product modification

040-0223-00

Type 575

SILICON RECTIFIER

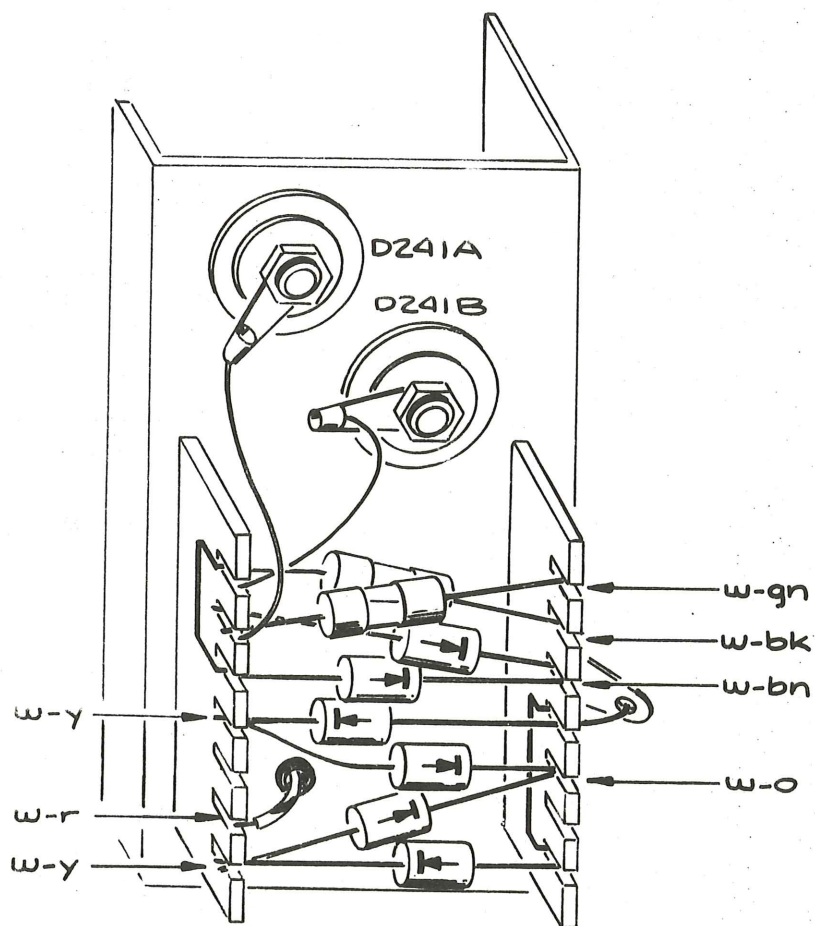
NOTE: Mount the solder lug between the screw head and the thermal cutout (see Fig. 1).

- () 6. Mount the silicon rectifier assembly (from kit), as shown in Fig. 1. Use the 6-32 x 0.516 PNH screws and flat washers from kit, placing a flat washer under each screw head. (Insert screws from bottom of chassis.)

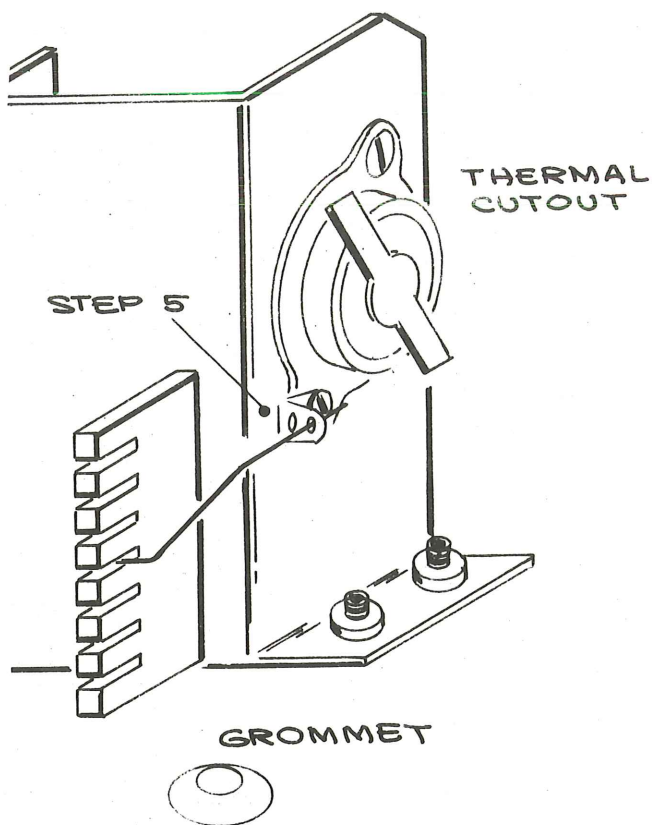
- () 7. Wire the silicon rectifier assembly, as shown in Fig. 2.

(See wiring schematic on following page.)

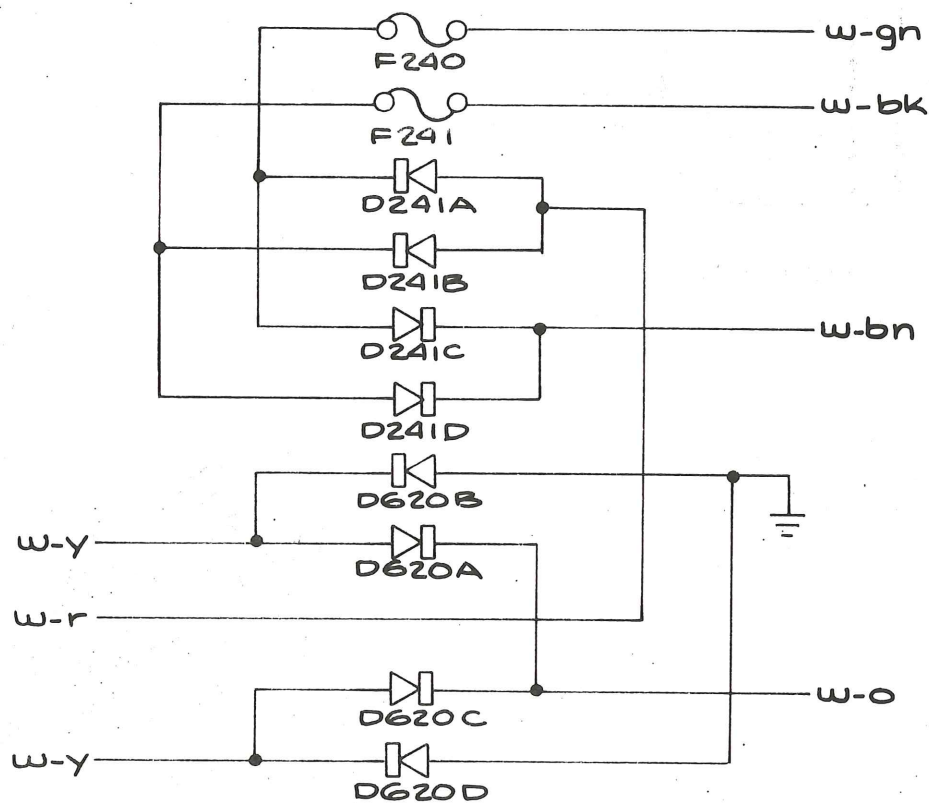
This modification replaced the selenium rectifiers with silicon rectifiers. Silicon rectifiers offer more reliability and longer life.

Ckt. No.	Part Number	Description			
DIODES					
D241A, B	152-0088-00	15 A	100 PIV	silicon	
D241C, D	152-0066-00	500-750 mA	400 PIV	silicon	
D620A, B, C, D	152-0066-00	500-750 mA	400 PIV	silicon	
FUSES					
F240	159-0053-00	5 A	fast-blo	w/pigtail	
F241	159-0053-00	5 A	fast-blo	w/pigtail
